# MEMORANDUM

**TO:** Planning Board Members  
**FROM:** Michael A. Lumbis, Planning and Community Development Director  
**PRIMARY REVIEWER:** Geoffrey T. Urda, Planner  
**SUBJECT:** Site Plan Approval – 155 Clinton Street  
**DATE:** June 1, 2023  
**Request:** Site Plan Approval to construct a 2,378 SF building addition, a 253 SF building addition and a 9,500 SF sq. ft. parking lot expansion at **155 Clinton Street**, Parcel Number 10-07-109.100  
**Applicant:** Design Build Innovations, LLC  
**Proposed Use:** Professional Office Building  
**Property Owners:** Clinton Center Development, LLC

**City of Watertown**  
**SITE PLAN APPROVAL APPLICATION FORM**

Clinton Center Redevelopment  
Multi-Tenant Professional Office Building  
155 Clinton Street  
Watertown, NY 13601

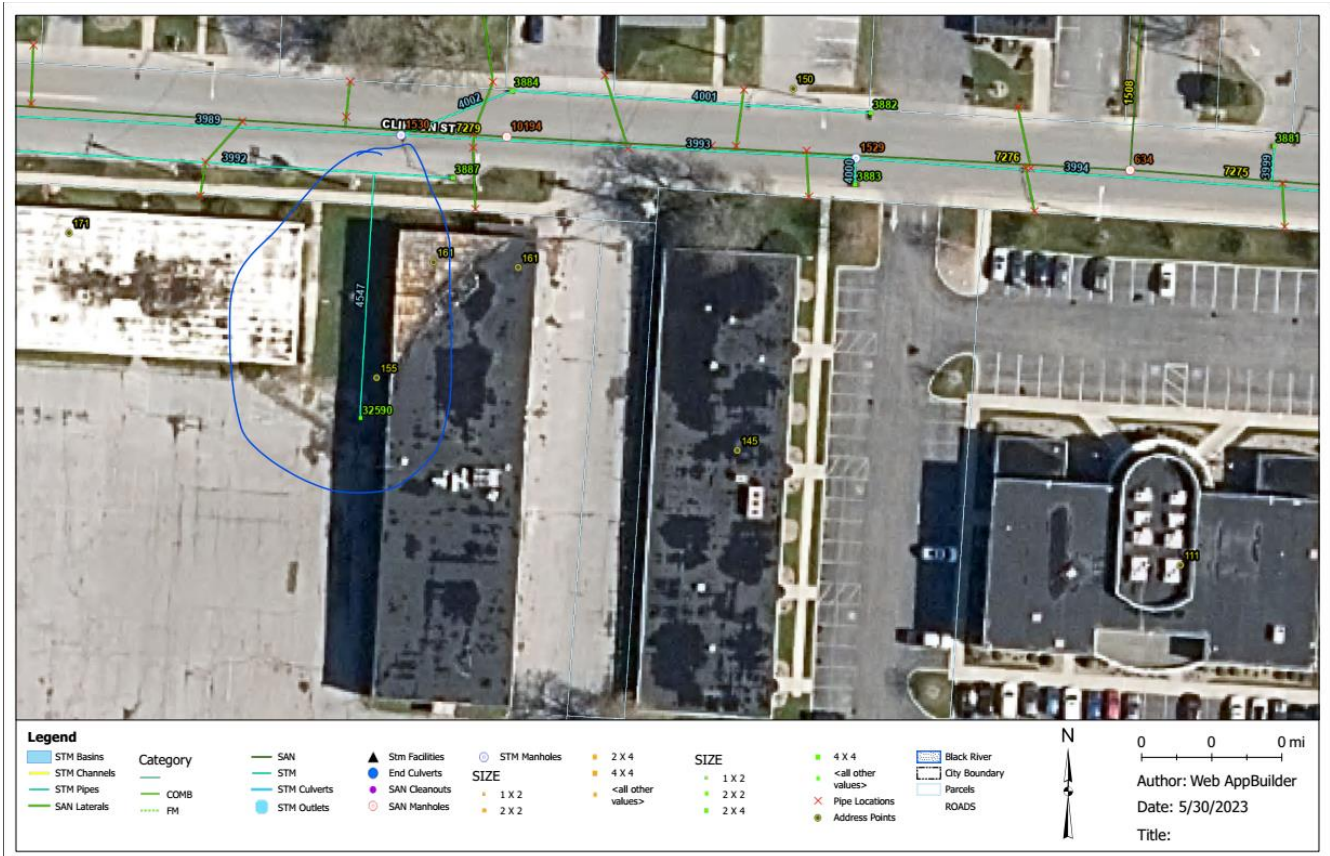
The applicant proposes two new trees at the northern edge of the property, one in the snow storage area at the corner of Sherman and Clinton Streets and one adjacent to the proposed curb cut on Clinton Street.

SHEET TITLE:  
SITE PLAN AND LANDSCAPING PLAN

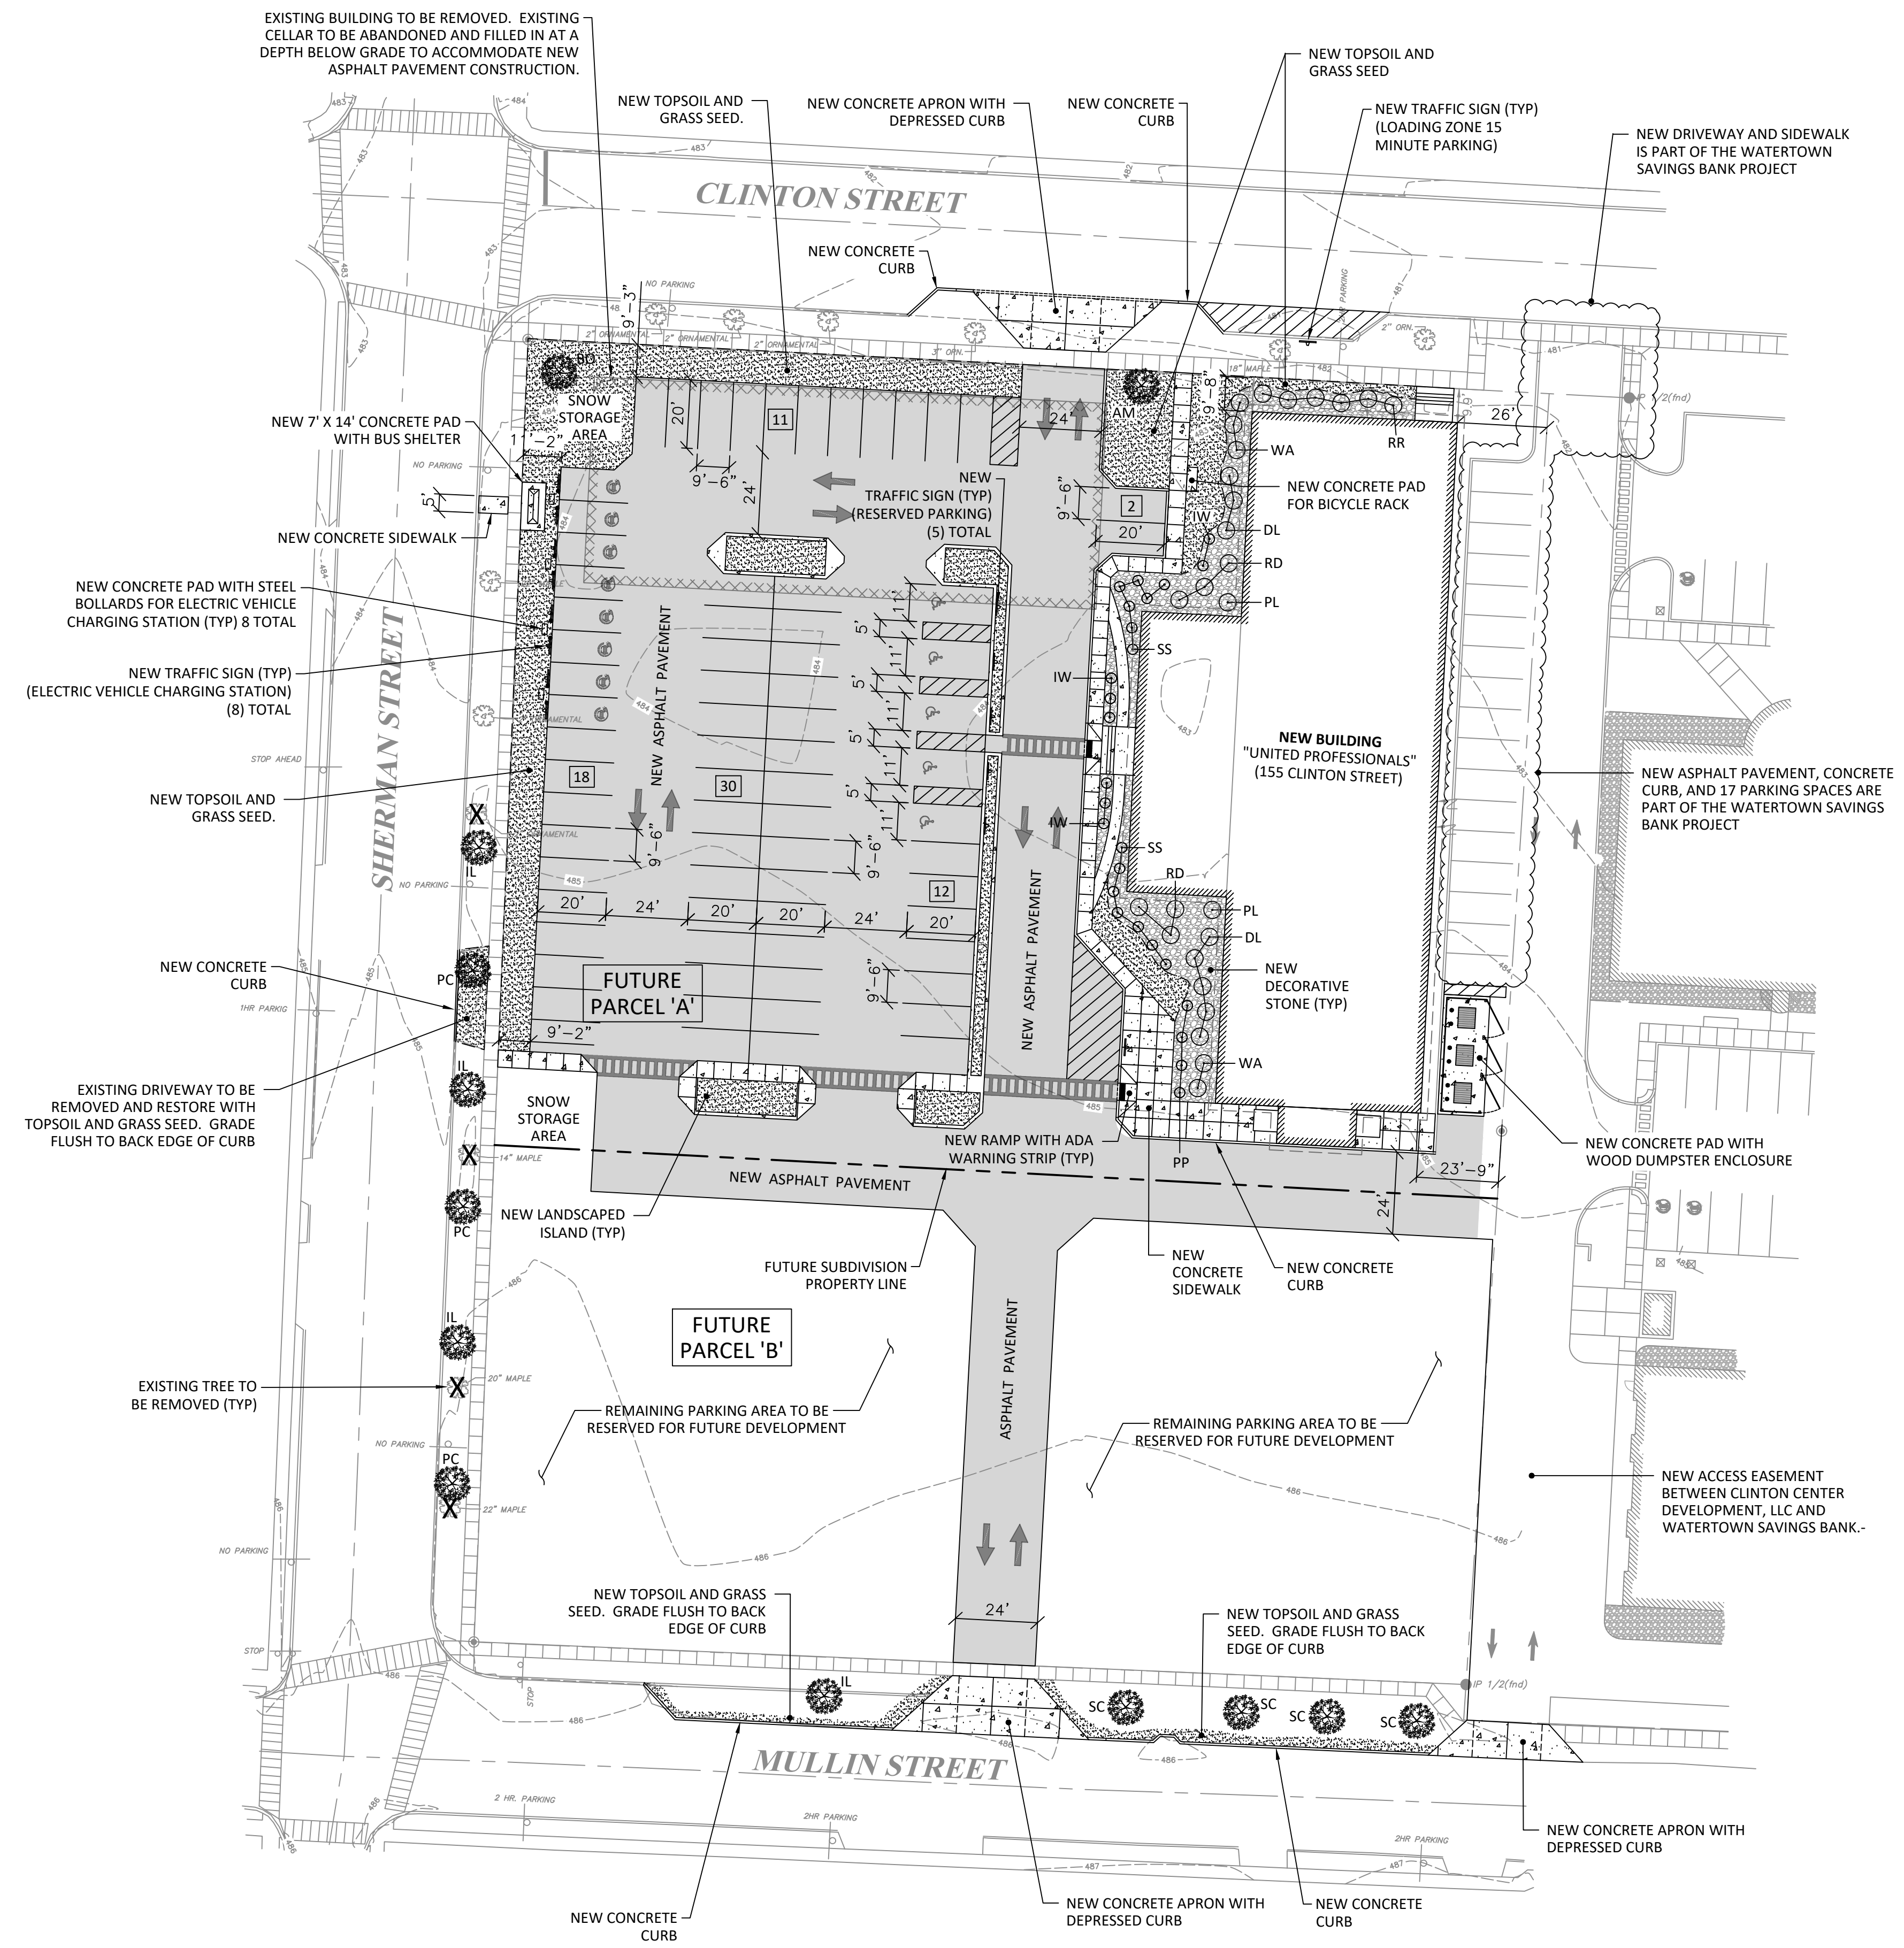
Finally, while the table identifies 89 spaces, the site plan drawing appears to contain 90 spaces. The applicant shall clarify this discrepancy.

**Vehicular and Pedestrian Circulation:** The applicant did not submit a formal Vehicular and Pedestrian Circulation Plan, which is a required drawing within a Site Plan Application package. The C102 (Site Plan) drawing contains some of the required elements of a Vehicular and Pedestrian Circulation Plan. However, it does not contain the movements of a City fire truck and a refuse vehicle. The analysis below is based on the information available on the C102 drawing.

Vehicular access to the proposed parking lot would be via curb cuts on both Clinton and Mullin Streets, connected by an internal north-south drive aisle that runs from one curb cut to the other. The applicant proposes a 24' wide drive aisle, which is sufficient for two-way internal traffic.

The applicant proposes an east-west internal drive aisle that would cross the eastern property line and connect directly to the adjacent WSB parking lot without the need to exit to the street. As discussed in the Comprehensive Plan section of this memorandum, the applicant also proposes an internal sidewalk network, connecting to/from Clinton and Sherman Streets.

The applicant is proposing a 9'-3"-wide landscaped strip along the ROW on Clinton Street, 5'-9" narrower than the Zoning Ordinance requires. Since this is a new parking area, the applicant is responsible for meeting all applicable requirements of the Zoning Ordinance and must increase the width to 15 feet.

The applicant proposes four interior landscaped islands as well as a landscaped area adjacent to the west façade of the building. However, the applicant only proposes topsoil with grass seed for the former and decorative stone gravel with shrubs for the latter.

The site plan, as submitted, does not depict any landscaping on the southern half of the parcel, where no development is proposed at this time. Although, the applicant does propose new tree planting in the street margins of Sherman and Mullin Street adjacent to the southern section of the site.

Both the C102 and C103 drawings contain contour lines. It appears that these are existing contours. The applicant must add a label to one of the drawings calling out the nature of the contour lines.

3. The applicant shall clarify the accurate number of proposed parking spaces on the site.
4. The applicant shall either add the movements of a City Fire Truck and a refuse/delivery vehicle to the C102 drawing or submit a formal Vehicular and Pedestrian Circulation Plan drawing.

5. The applicant shall either provide a 15-foot-wide landscaped strip with trees along the Right-of-Way (ROW) on Clinton Street or apply for and obtain an Area Variance from the Zoning Board of Appeals granting relief from this requirement.

6. The applicant shall either add interior parking lot trees to the Landscaping Plan to meet the requirements of the Zoning Ordinance or apply for and obtain an Area Variance from the Zoning Board of Appeals granting relief from the requirements.

10. The applicant shall add a label to either the C102 or C103 drawing that identifies whether the depicted contour lines are existing or proposed.
11. The applicant must either add grading, invert elevation information, pipe slopes and other pertinent data to the C103 drawing or submit a dedicated Grading Plan drawing with all required information.

SHEET TITLE:  
**SITE UTILITY PLAN**

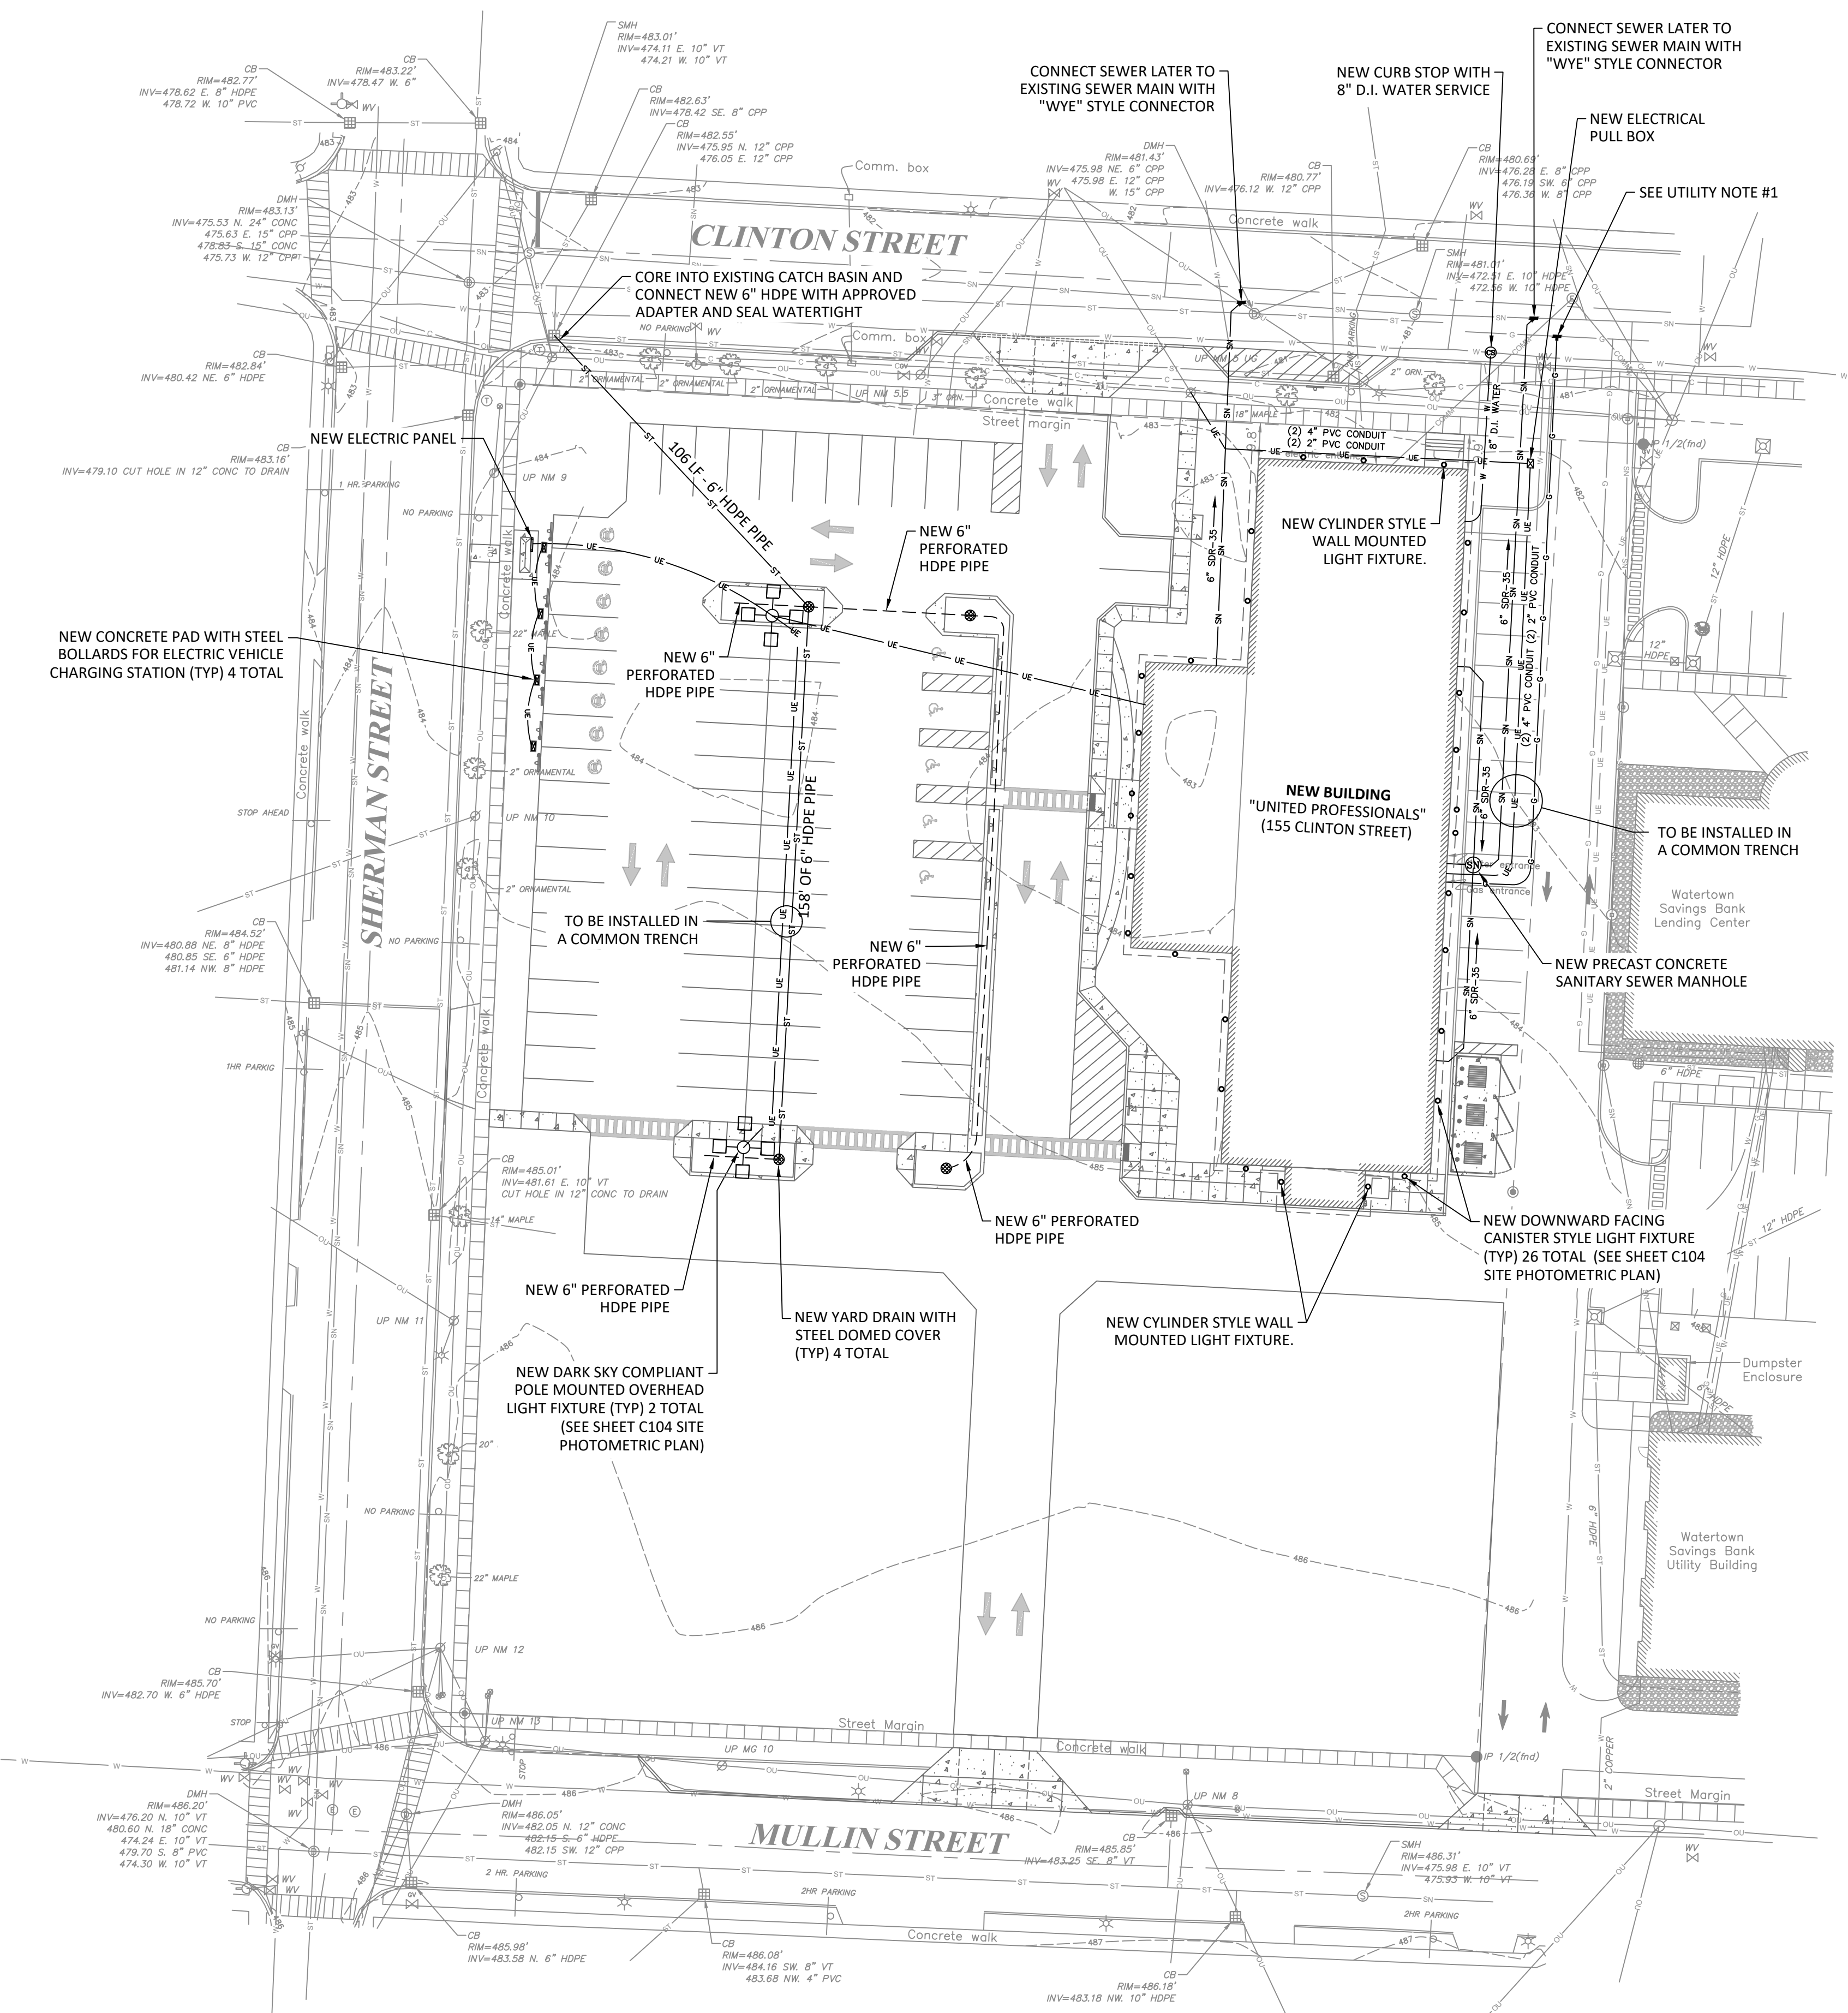
**Grading, Drainage and Utilities:** The C103 (Utility Plan) depicts a sanitary sewer line extending south from Clinton Street to the proposed western building addition. There is an existing storm sewer line in that location now (see image on next page). There is also an existing catch basin at the south end of the storm line that would be directly underneath the proposed western building addition.

The applicant shall clarify to the City Engineering Department exactly what is proposed for this pipe and catch basin. If both are proposed for elimination, the applicant shall add a note to the site plan to that effect and clarify for Staff if this will be mitigated elsewhere on the site.

In addition, the storm line identified above connects to an existing storm line in the Clinton Street ROW underneath the section where the applicant proposes to expand the margin and move the curb line out. The applicant shall be aware of this storm line and avoid damaging it during construction.

The applicant did not submit a Grading Plan and there are no proposed contours or spot elevations shown on the site utility plan. The applicant is proposing several landscaped islands containing yard drains with steel domed covers, connected by 6” HDPE pipe. This parking lot drainage system connects to a City catch basin located at the southeast corner of the Clinton St./Sherman St. intersection. The applicant must either add grading, invert elevation information, pipe slopes and other pertinent data to the C103 drawing or submit a dedicated Grading Plan drawing with all required information.

Additionally, the City will require a manhole boot connector (a.k.a.: boot style connection) in the City catch basin. The applicant shall also add a construction detail and note providing information regarding the proposed connection to the City catch basin.

The applicant states in the Engineering Report that “the local energy provider will be responsible for the installation of the new service to the existing pole.” The applicant must coordinate this with National Grid. The applicant shall also depict and label all existing and proposed fire hydrants.

8. The applicant shall clarify what is proposed regarding the existing storm sewer line connecting from Clinton Street and the catch basin it connects to, as it relates to the sanitary sewer line depicted on the C103 drawing.

9. The applicant shall be responsible for preventing damage to the existing storm line underneath Clinton Street where the applicant is proposing to widen the margin and move the curb line.

12. The applicant must add a construction detail and note providing information regarding the proposed manhole boot connector that will be required for connection to the City catch basin.

15. The applicant should consider incorporating some form of stormwater retention system on the site.
16. The applicant shall depict and label all existing and proposed fire hydrants on the plan drawing.
